#### West End (Landmark)

Blocks E&G Amendment – DSUP#2023-10008 Comprehensive Sign Plan – SUP#2023-00011 Open Spaces – DSUP#2023-10004

5801 Duke Street

Planning Commission September 5, 2023

## Proposed Changes to Block E Layout

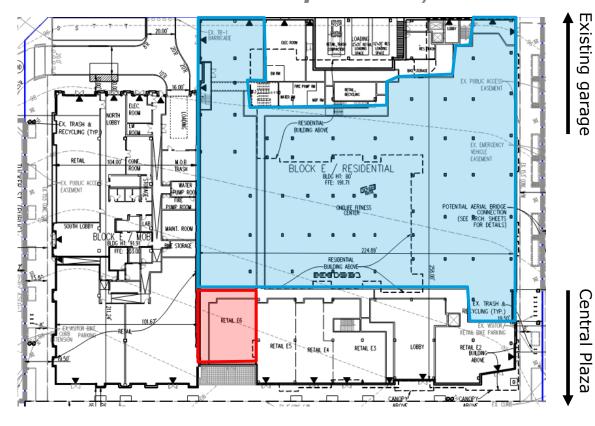
DSUP#2022-10017 Approved Plan

- At-grade Courtyard
- Individual retail bays

DSUP#2023-10008 Proposed Layout

- Enlarged retail bay with mezzanine (E7)
- New retail bay (E6)

- Optional changes limited to Block E residential building
- Increased Floor Area:
  - +5,310 SF infilled courtyard
  - +27,555 SF mezzanine in retail bay E7\*
- Redistributed Open Space:
  - -2,823 SF at-grade open space
  - +1,880 SF above-grade courtyard
  - +770 SF Block P transfer\*\*
- Meets Stormwater Requirement: 1.79 lbs. phosphorous removed (vs. 1.78 required)
- Commercial parking no longer exceeds maximum (297 spaces provided)

### Garage Banners Not Supported

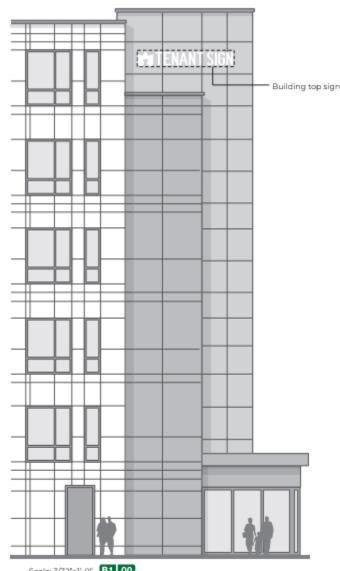
Proposed:

- 12 signs (max.)
- 100 SF (max.)
- Materials:
  - Channel letters or logos
  - Static banner elements
- Zoning Ordinance requires signs to be high aesthetic quality
- Staff supports channel letters or logos but not banners due to maintenance concerns

- Blocks E&G Amendment, DSUP#2023-10008
  - Staff recommend <u>approving this option</u> for flexibility in developing Block E subject to conditions in staff report
- Comprehensive Sign Plan, SUP#2023-00011
  - Staff recommend <u>approving</u> subject to revisions (incl. removing garage banners)
- Open Spaces, DSUP#2023-10004
  - Staff recommend <u>approving</u> subject to conditions in staff report
